Report Date: September 2, 2026

Report Number: 265984

Deep Water Recovery Ltd.
5084 Island Highway S.
PO Box 276
Union Bay BC V0R 3B0

Re: Investigation Referral

Appendix 1: Site Plan

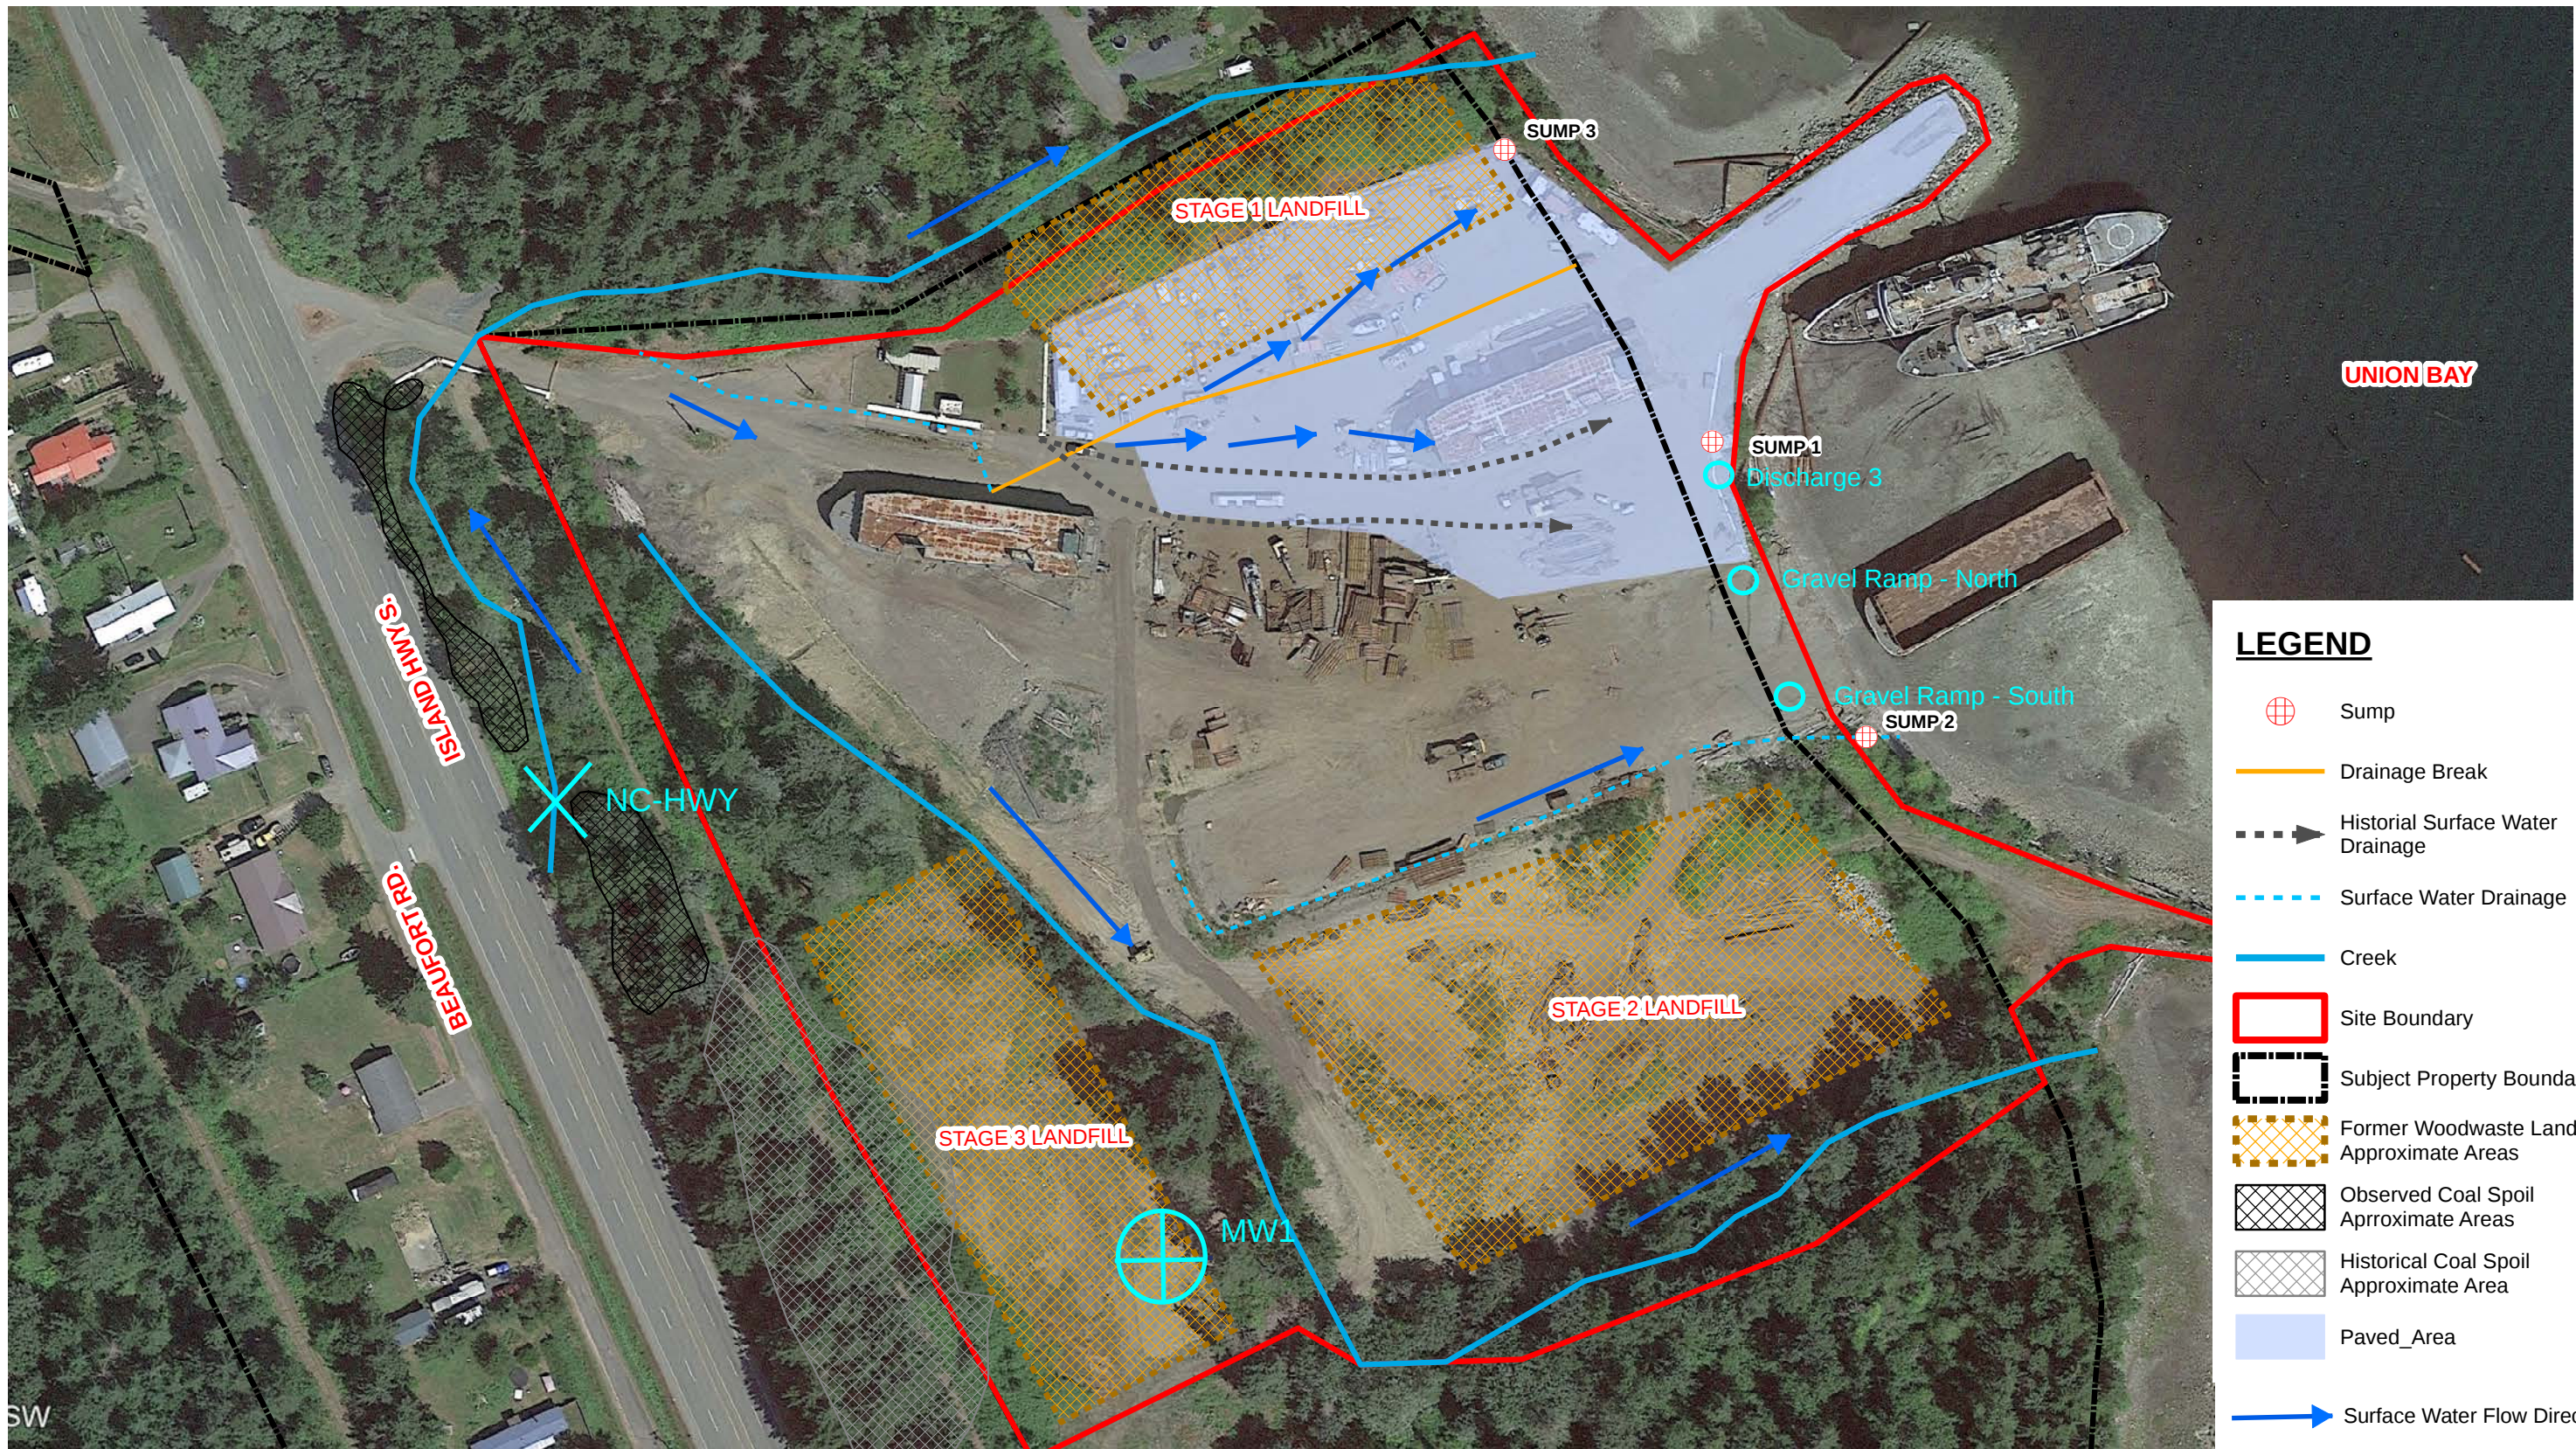
According to the May, June and July 2026 Monitoring Reports, there were no observed discharges from Sump 1, 2 or Sump 3 during those months (See Appendix 1: Site Plan for sump locations.) Therefore, DWR was in compliance with this requirement during the Inspection Period.

Appendix 2: Treatment Plan Action Locations
(Figure 1 from 2024 Mitigation and Treatment Plan, Dated October 2024)

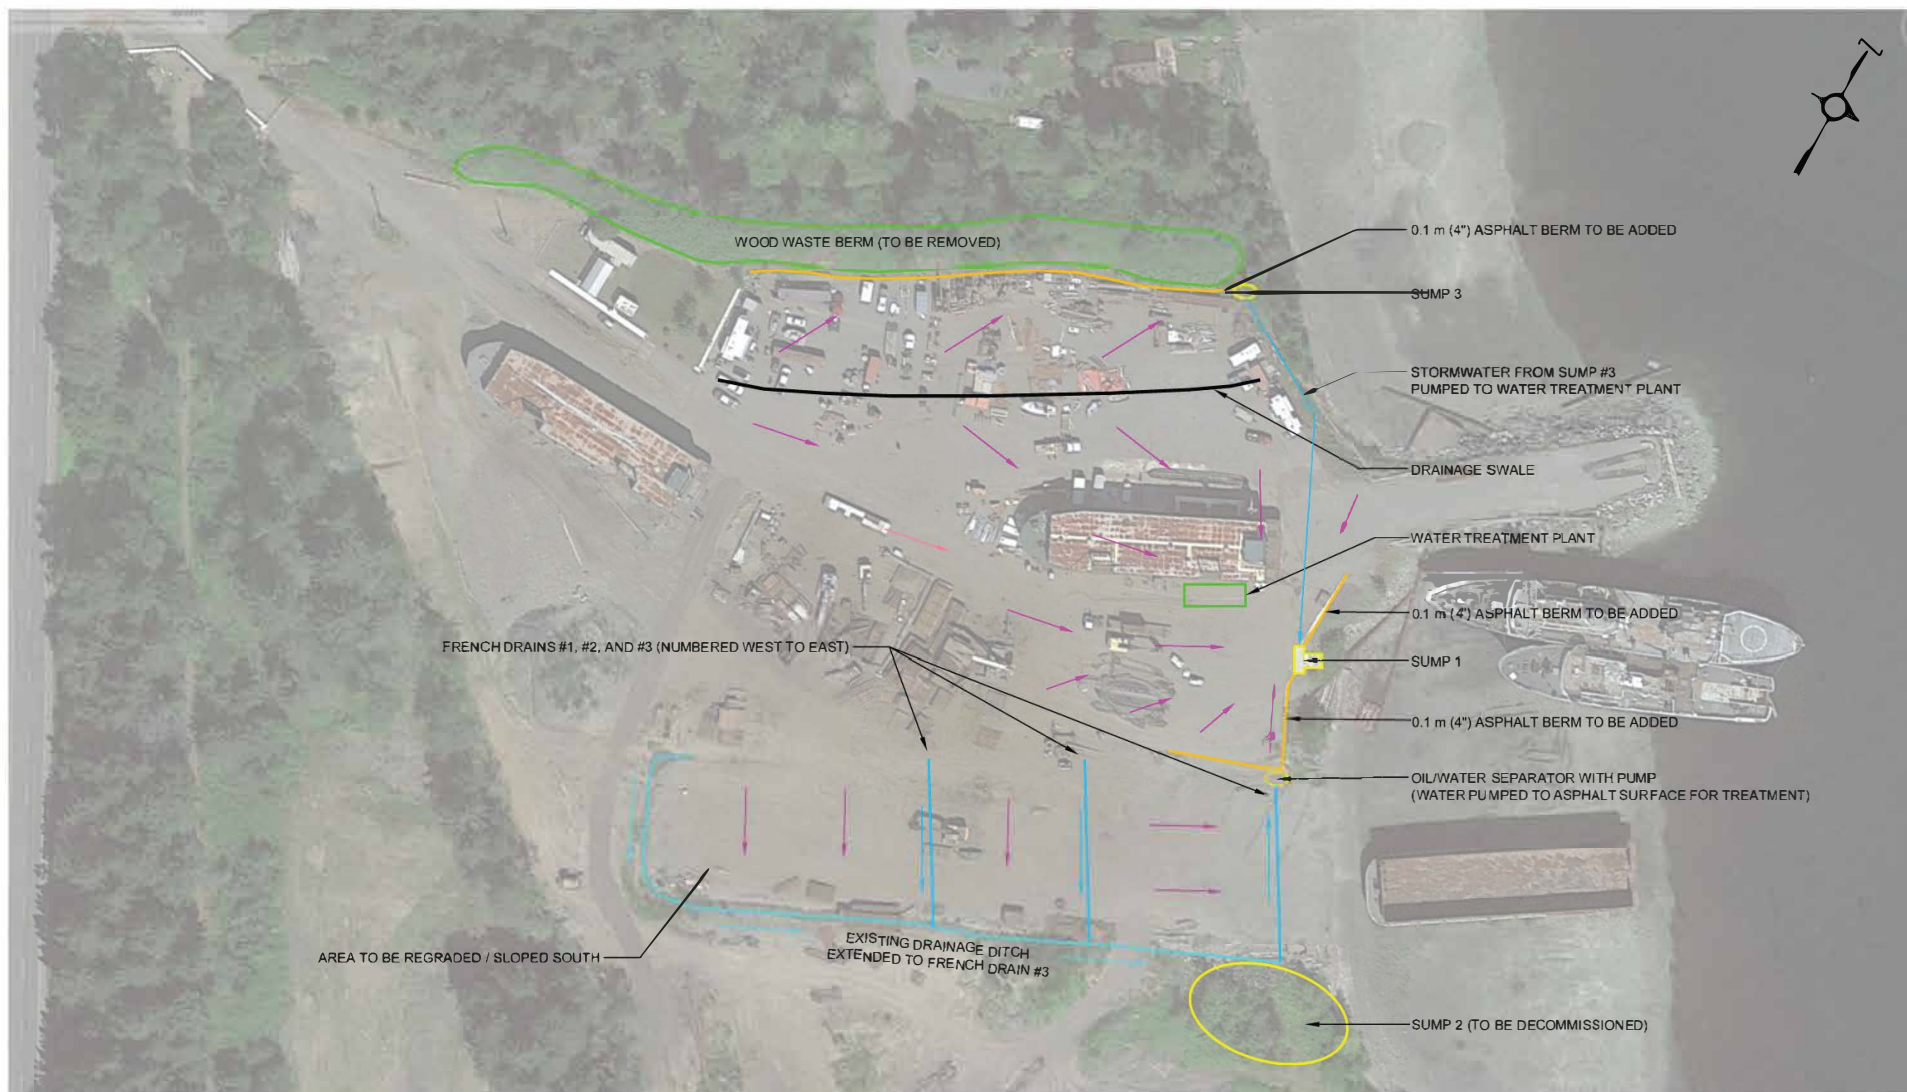
Portions of the berm at the south end of the oil water separator are visible in the biweekly monitoring photos taken by DWR on May 21, May 28, May 29, June 4, June 5, June 10, June 12, June 17, June 24, June 26, July 1, July 3, July 10, July 15, July 22, July 24, July 29 and July 31, 2026, as submitted in the May, June and July 2026 Monitoring Reports. The photos showed that the berm height had not been raised.

As the berm height had not been increased, DWR was out of compliance with Order Requirement 4(B) from May 1, 2026 to July 31, 2026.

The monthly monitoring reports submitted during the Inspection Period include bi-weekly monitoring photos taken by DWR from May 6, 2026 to July 31, 2026. Each bi-weekly inspection included Sump 2 and each image, up to and including July 31, 2026, showed Sump 2 was still in place and that vegetation has not been removed.

The monthly monitoring reports submitted during the Inspection Period included bi-weekly monitoring photos taken by DWR from May 6, 2026, to July 31, 2026. These images of Sump 3 showing that, up to and including July 31, 2026, the sump was still in place and that vegetation had not been removed.

Immediately increase the berm height at the north and south ends of the oil/water separator by a minimum of 10 cm (4 inches), as detailed in Section 2.0 and Figure 1 (Appendix A) of the Plan.

Decommission Sump 2 immediately following completion of Required Actions 4(D), 4(E) and 4(F),

Immediately decommission Sump 3.
